Stage 04: Draft Final Modification Report

GC0118:

Mod Title: Modification to the Grid Code to accommodate the recent Distribution Code modification to Engineering Recommendation P28 – *Voltage fluctuations and the connection of disturbing equipment to transmission systems and distribution networks in the United Kingdom.*

Figure CC.6.1.7 -
Time and magnitude limits for a category 3 Rapid Voltage Change

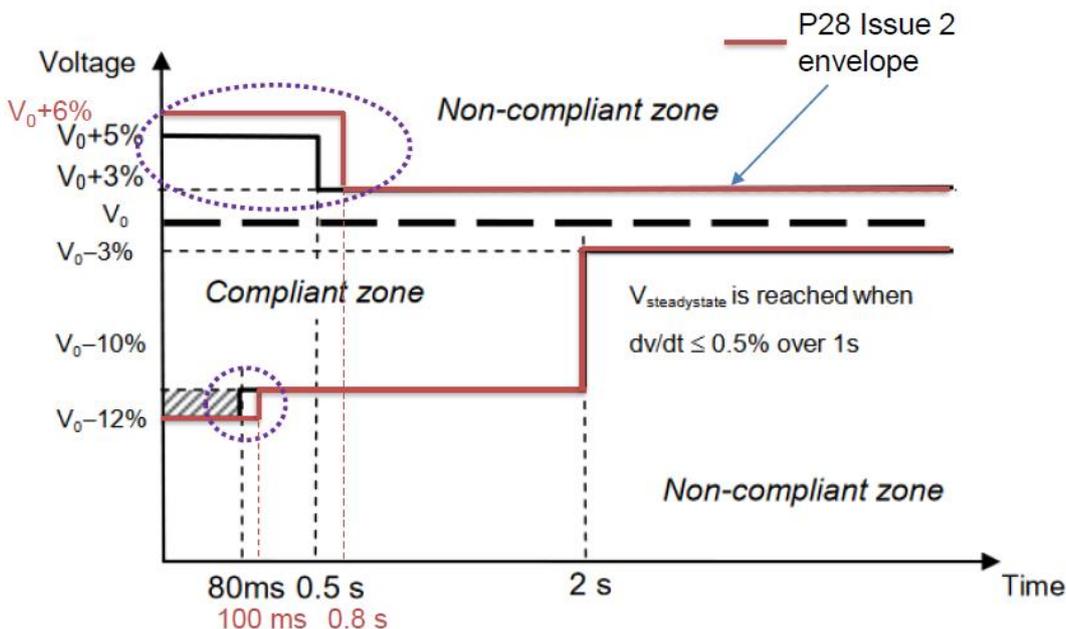
The difference between the voltage envelope for Rapid Voltage Changes in Figure CC.6.1.7 of the Grid Code (the black lines denote the existing requirement) and Table 4 of EREC P28 Issue 2 (the red lines denote the proposed requirement) for Very Infrequent RVCs are shown in the above figure. The Distribution Code Review Panel P28 Working Group has proposed limits for RVC in EREC P28 Issue 2 that:

- generally align with those in Figure CC.6.1.7 of the Grid Code for reductions in voltage.
- are absolute and compatible with EREC G59 and the interface protection requirements for generation connected to distribution systems as well as National Grid's Technical Guidance Note (TGN) 288 for overvoltage.
- are compatible with immunity levels for customer equipment.
- should not result in unacceptable disturbance provided:-
 - events are sufficiently spaced apart.
 - multiple RVCs are completed within a small time window.

Figure CC.6.1.7 (1) — Voltage characteristic for frequent events

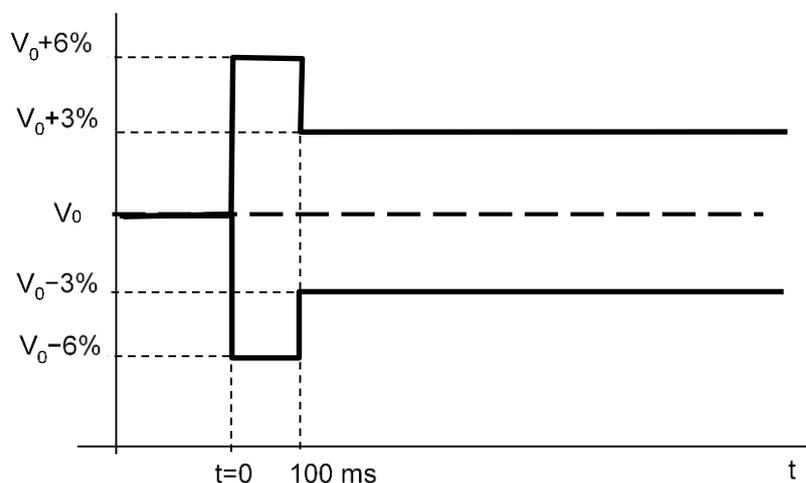
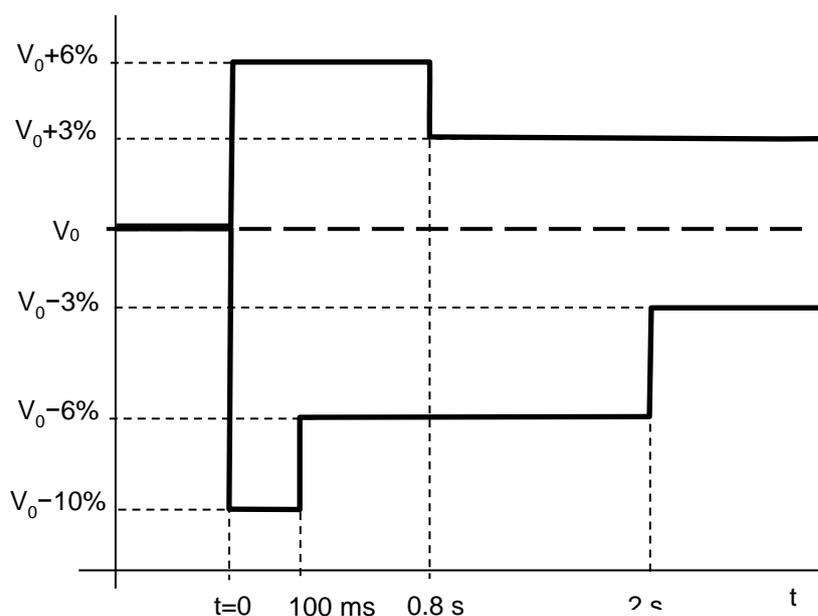
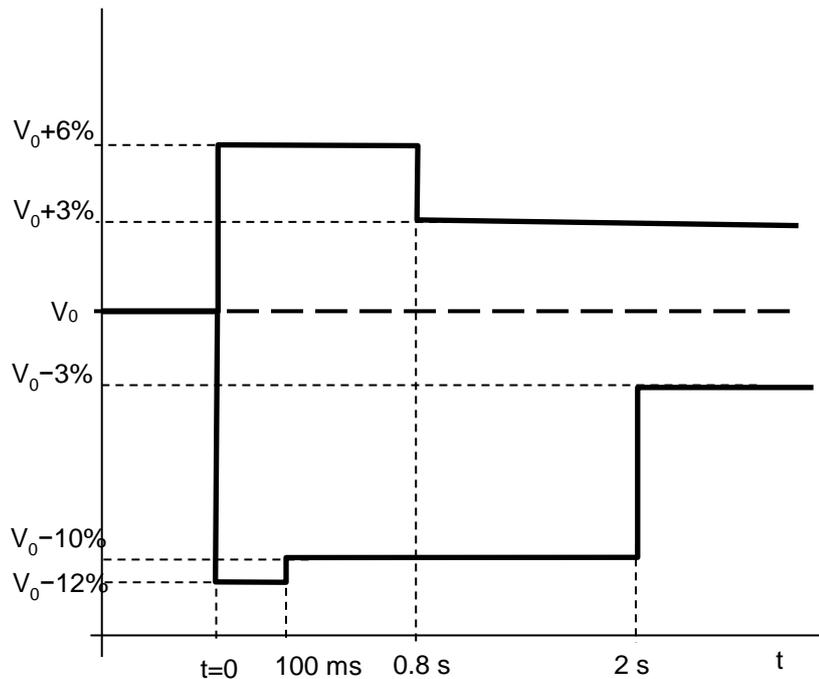
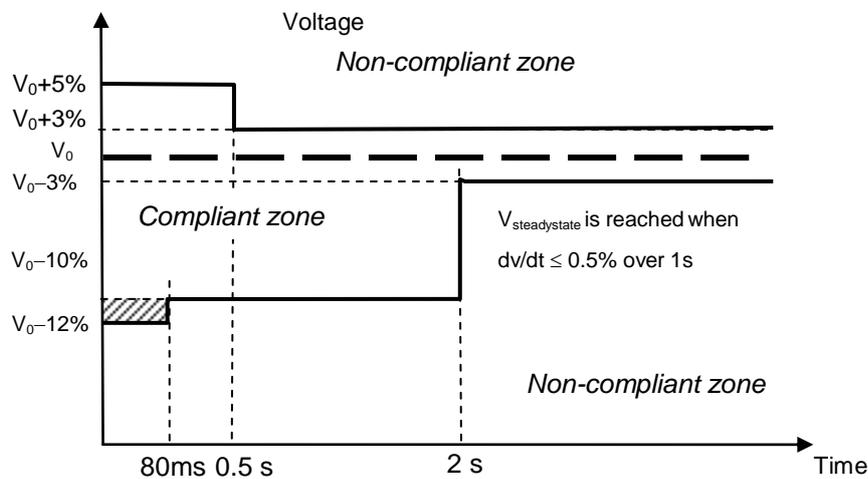
NOTE 1: $\pm 6\%$ is permissible for 100 ms reduced to $\pm 3\%$ thereafter as per Figure CC.6.1.7 (1).
If the profile of repetitive voltage change(s) falls within the envelope given in Figure CC.6.1.7 (1), the assessment of such voltage change(s) shall be undertaken according to the recommendations for assessment of flicker and shall conform to the planning levels provided for flicker.
If any part of the voltage change(s) falls outside the envelope given in Figure CC.6.1.7(1), the assessment of such voltage changes, repetitive or not, shall be done according to the guidance and limits for RVCs.

NOTE 3: -10% is permissible for 100 ms reduced to -6% until 2 s then reduced to -3% thereafter as per Figure CC.6.1.7 (1).

NOTE 4: $+6\%$ is permissible for 0.8 s from the instant the event begins then reduced to $+3\%$ thereafter as per Figure CC.6.1.7 (2).

NOTE 5: -12% is permissible for 100 ms reduced to -10% until 2 s then reduced to -3% thereafter as per Figure CC.6.1.7 (3).

NOTE 6: $+6\%$ is permissible for 0.8 s from the instant the event begins then reduced to $+3\%$ thereafter as per Figure CC.6.1.7 (3).

Figure ECC.6.1.7 (1) — Voltage characteristic for frequent events

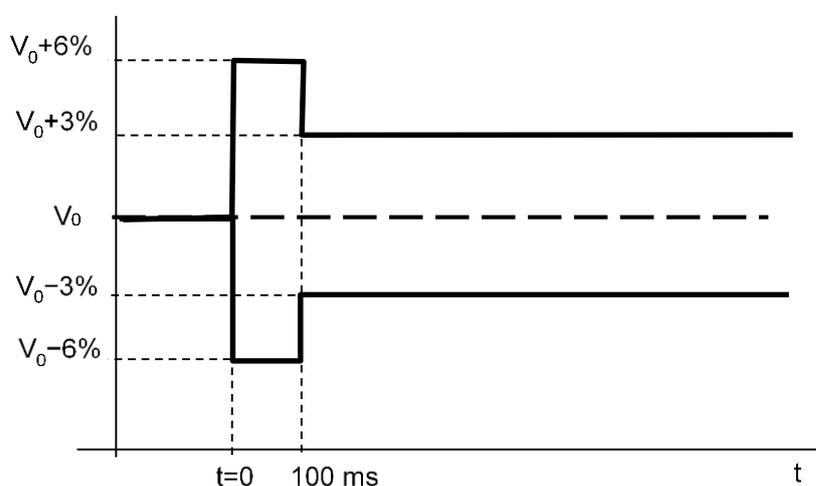
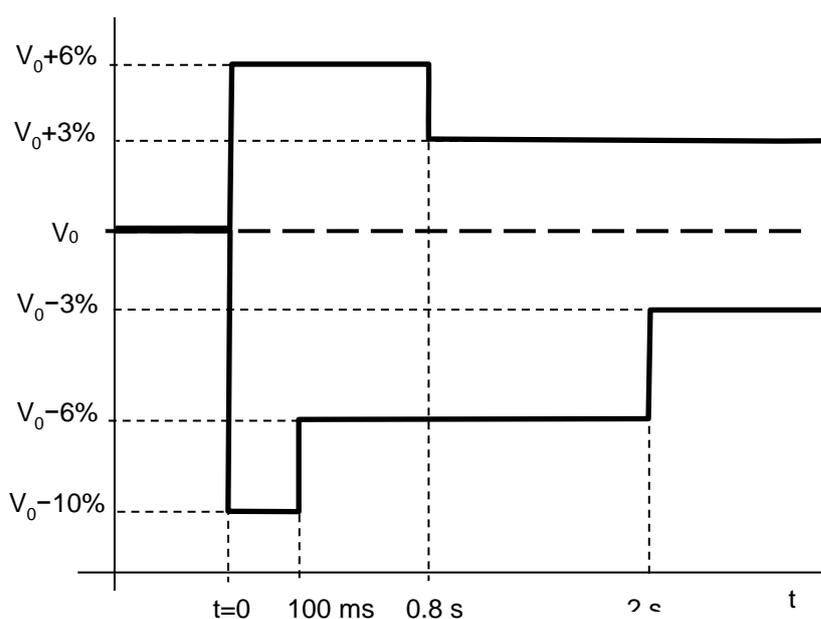
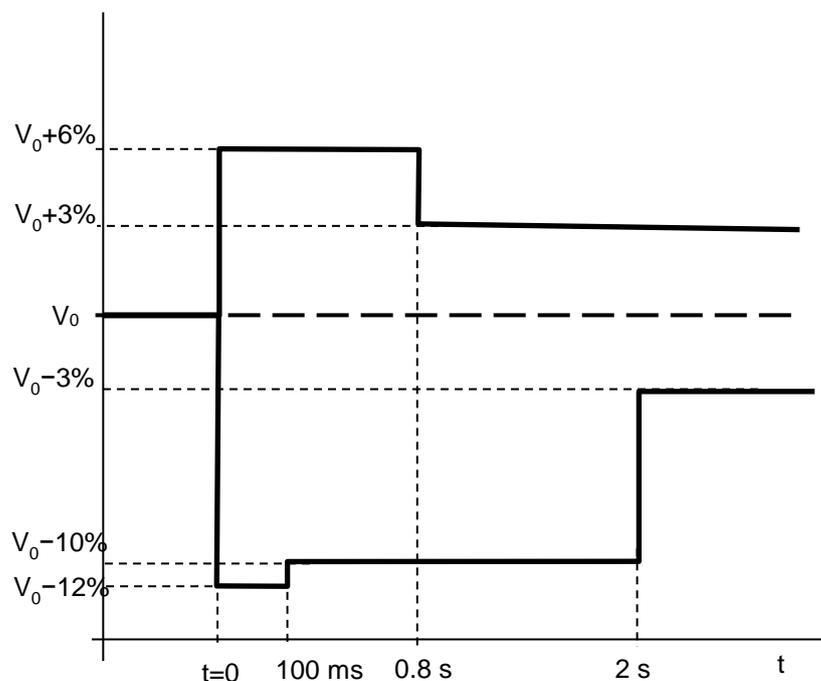
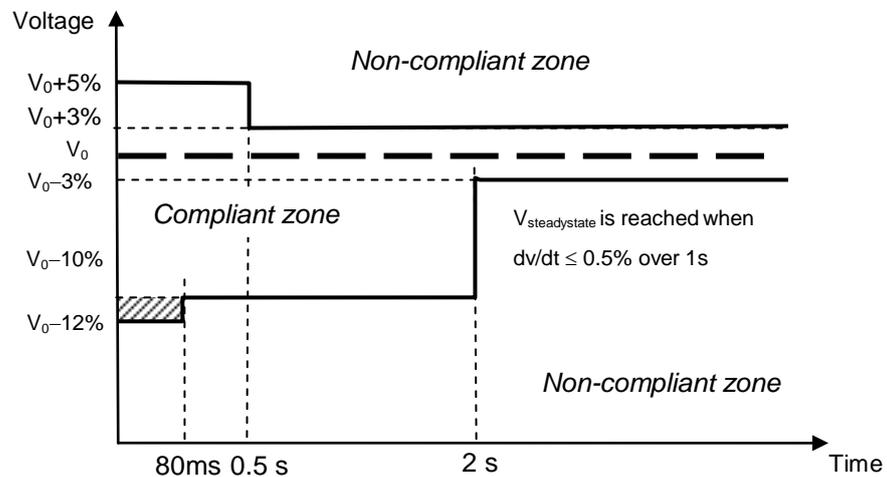
NOTE 1: $\pm 6\%$ is permissible for 100 ms reduced to $\pm 3\%$ thereafter as per Figure ECC.6.1.7 (1). If the profile of repetitive voltage change(s) falls within the envelope given in Figure ECC.6.1.7 (1), the assessment of such voltage change(s) shall be undertaken according to the recommendations for assessment of flicker and shall conform to the planning levels provided for flicker. If any part of the voltage change(s) falls outside the envelope given in Figure ECC.6.1.7(1), the assessment of such voltage changes, repetitive or not, shall be done according to the guidance and limits for RVCs.

NOTE 3: -10% is permissible for 100 ms reduced to -6% until 2 s then reduced to -3% thereafter as per Figure ECC.6.1.7 (1).

NOTE 4: $+6\%$ is permissible for 0.8 s from the instant the event begins then reduced to $+3\%$ thereafter as per Figure ECC.6.1.7 (2).

NOTE 5: -12% is permissible for 100 ms reduced to -10% until 2 s then reduced to -3% thereafter as per Figure ECC.6.1.7 (3).

NOTE 6: $+6\%$ is permissible for 0.8 s from the instant the event begins then reduced to $+3\%$ thereafter as per Figure ECC.6.1.7 (3).

Figure B.1.2 — $P_{st} = 0.5$ curve for rectangular voltage changes

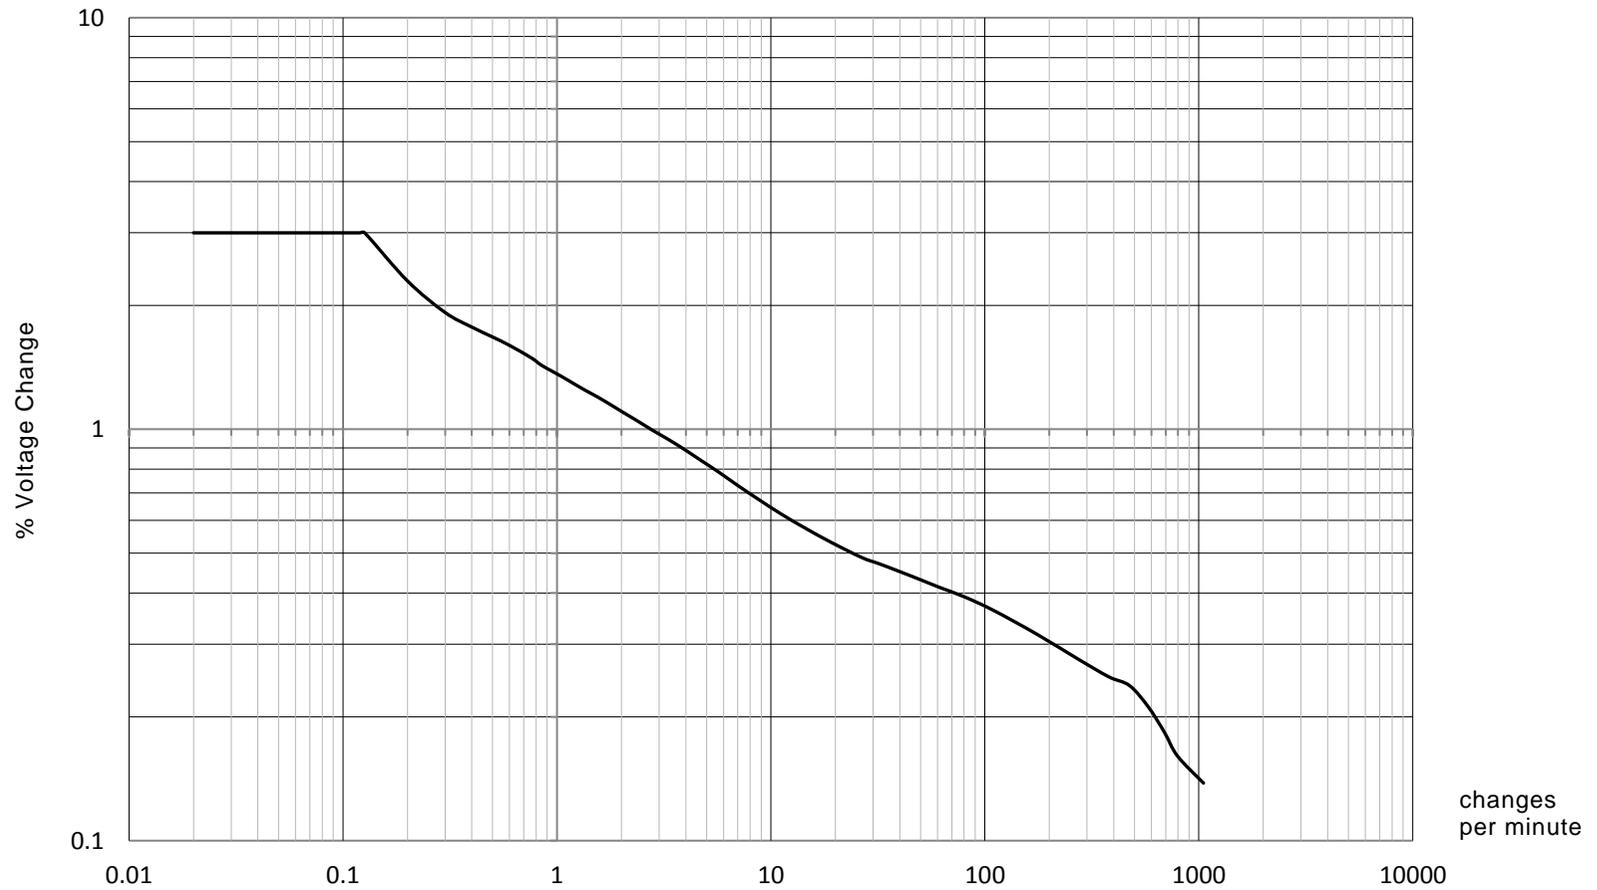
- b) The same respondent also noted there is a reference to current version P28 figure 4 in the SQSS and EREC P28 Issue 2 replaces the original figure 4 with figure B.1.2 and asked for confirmation whether these are the same and whether the SQSS will be corrected?

- i) The Working Group note the acknowledgment in the SQSS that EREC P28 Issue 1 Figure 4 was used in the derivation of Figure 6.1 'Maximum Voltage Step Changes Permitted for Operational Switching'. Figure B.1.2 in EREC P28 Issue 2 is intended to replace Figure 4 in EREC P28 Issue 1 but has been aligned with the current flicker severity curve in Figure A.1 of PD IEC/TR 61000-3-7 – except that the curve has been deliberately capped at a maximum symmetrical step voltage change of 3% once every 475 s. Consequently, the curve in Figure B.1.2 in EREC P28 Issue 2 differs from that in Figure 4 of EREC P28 Issue 1 and Figure 6.1 of the SQSS. The P28 Working Group recommend that Figure 6.1 in the SQSS is reviewed in light of the current flicker severity curve in Figure A.1 of PD IEC/TR 61000-3-7 and the aligned Figure B.1.2 in EREC P28 Issue 2.

Figure 5 — Voltage characteristic for frequent events (Category 1)

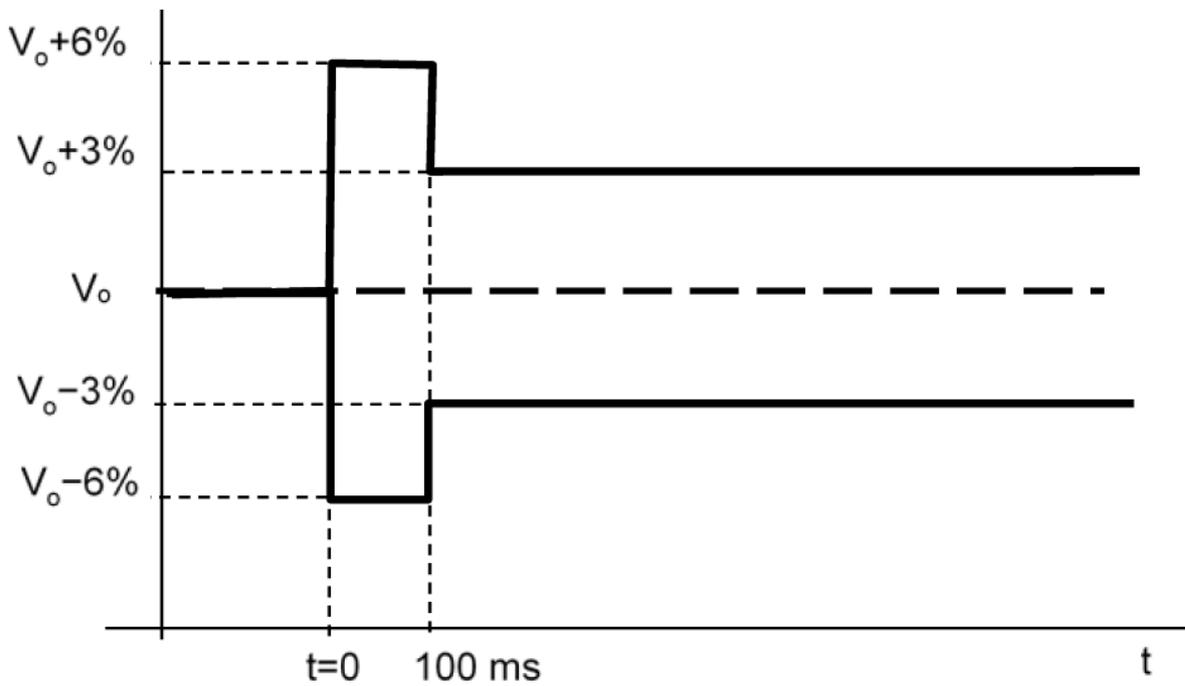
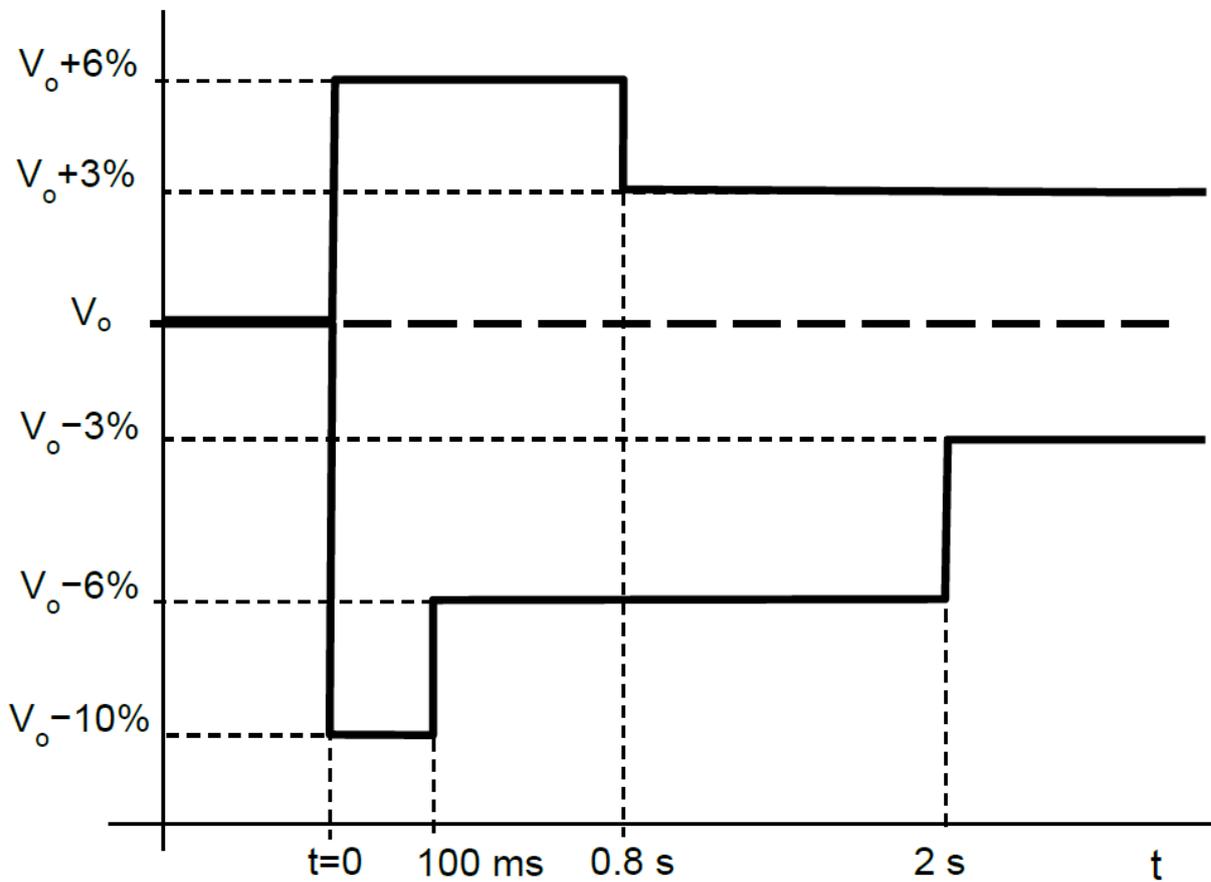
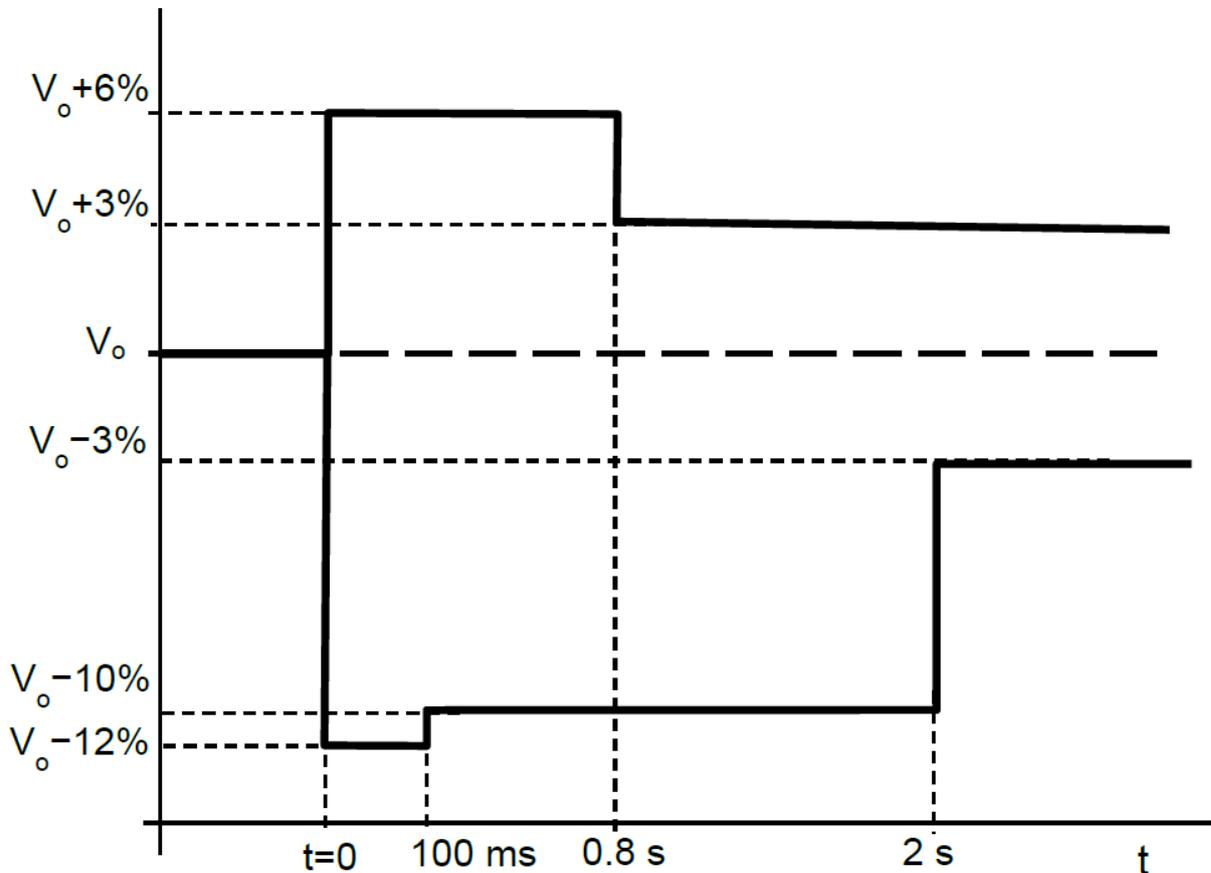
- 5.6 However, two of the respondents provided extensive comments in relation to the proposed requirements and planning levels for RVCs as provided in Figure 5, Figure

6, Figure 7 and Table 4 of EREC P28 Issue 2 (see Question 1). The responses to Question 1 related to the following.

i) In response, the Working Group do not believe the requirements in EREC P28 Issue 2 are more onerous than Category 2 of Grid Code CC.6.1.7. The time and voltage magnitude limits for Category 3 RVCs shown in Figure CC.6.1.7 of the Grid Code when compared with Figure 7 of EREC P28 Issue 2 confirm that both the time and voltage limits in EREC P28 Issue 2 for Category 3 very infrequent events (not more than 4 RVCs in 1 day providing less frequent than once every 3 calendar months) are less onerous than those for Category 3 RVCs in the Grid Code.
